### **REMARKS/ARGUMENTS**

The claims pending in the subject application are directed to a voice coil actuator in which first and second magnets and a first soft magnetic pole piece are positioned along a common axis. A coil having a length less than the first soft magnetic pole piece is positioned to travel along the common axis. Also included is a structure that provides a magnetic path between the free ends of the magnets with respect to the first soft magnetic pole piece.

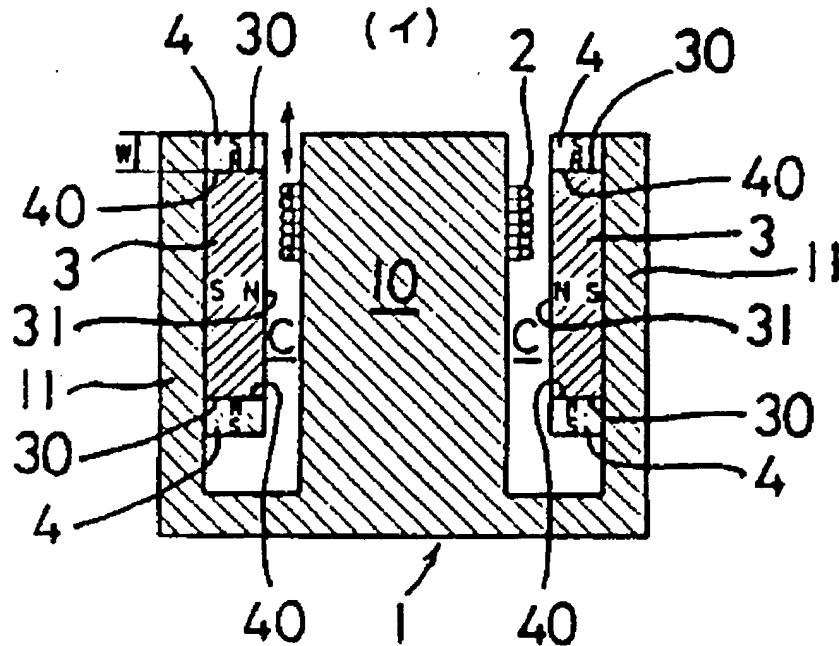
The Examiner has relied upon JP 62-173968 (inventor: Shinichi Hayashi et al.) to reject claims 1-3, and 5-6 under 35 U.S.C. 102(b), and claim 4 under 35 U.S.C. 103(a). Applicant respectfully traverses this rejection.

It is respectfully submitted that the structure in JP 62-173986 being relied upon by the Examiner is an all-permanent magnet structure. The disclosed structure of JP 62-173986 employs "auxiliary permanent magnet 4" in order to improve the flatness of the force curve over a larger stroke compared to that produced by the original motor design which employed "operating permanent magnet 3." That is, the original design being improved upon in JP 62-173986 employs "operating permanent magnet 3" as the main permanent magnet of the motor, with the auxiliary magnets 4 being used to enlarge the gap magnetic field, that is, to enlarge the "flat" portion of the response curve, see Fig. 6.

It is respectfully submitted that the "operating permanent magnet 3" of the JP 62-173968 is not a "soft magnetic pole piece," and because of this the disclosed structure of JP 62-173968 is fundamentally different from the claimed voice coil actuator. In the DICTIONARY OF SCIENTIFIC AND TECHNICAL TERMS, Fourth Edition, McGraw-Hill, 1989, the term "permanent magnet" is defined as:

According to these definitions, the "operating permanent magnet 3" of JP 62-173968 cannot be a "soft magnetic" pole piece because a "permanent magnet" would be understood by one skilled in the art to be strongly magnetized and to retain its magnetism indefinitely, and therefore not a "soft magnetic" pole piece. In contrast, a "soft magnetic material" such as that used in a "soft magnetic pole piece" of the claimed invention, would be understood by one skilled in the art to be relatively easily magnetized or demagnetized, and therefore not a "permanent magnet."
